MIL-R-83536/16A
AMENDMENT 2
15 December 95
SUPERSEDING
AMENDMENT 1
3 August 1994

MILITARY SPECIFICATION

RELAYS, ELECTROMAGNETIC, ESTABLISHED RELIABILITY, 4PDT,
LOW LEVEL TO 10 AMPERES, PERMANENT MAGNET DRIVE, HERMETICALLY SEALED,
ALL WELDED, TRANSIENT SUPPRESSED DC COIL

SOCKET PIN TERMINAL

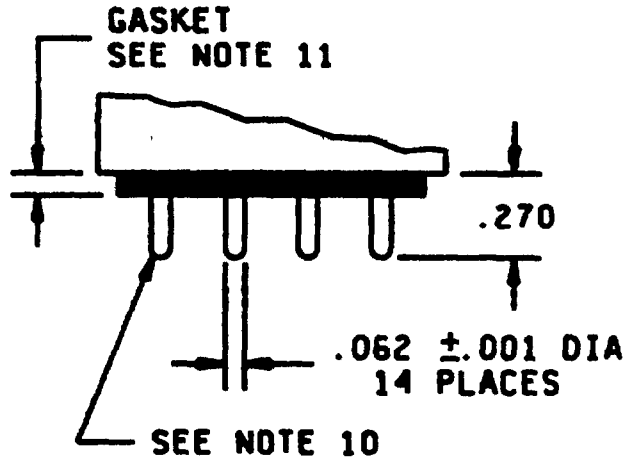
* FIGURE 1, socket pin terminal diagram, delete and substitute:

CIRCUIT DIAGRAM (TRACK MOUNT)
(OPTIONAL INTERNAL
DIODE CONFIGURATION)

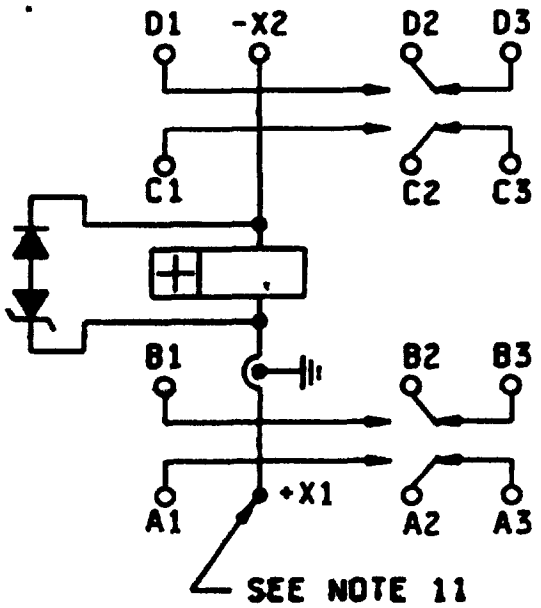
* FIGURE 2, add the following new circuit diagram
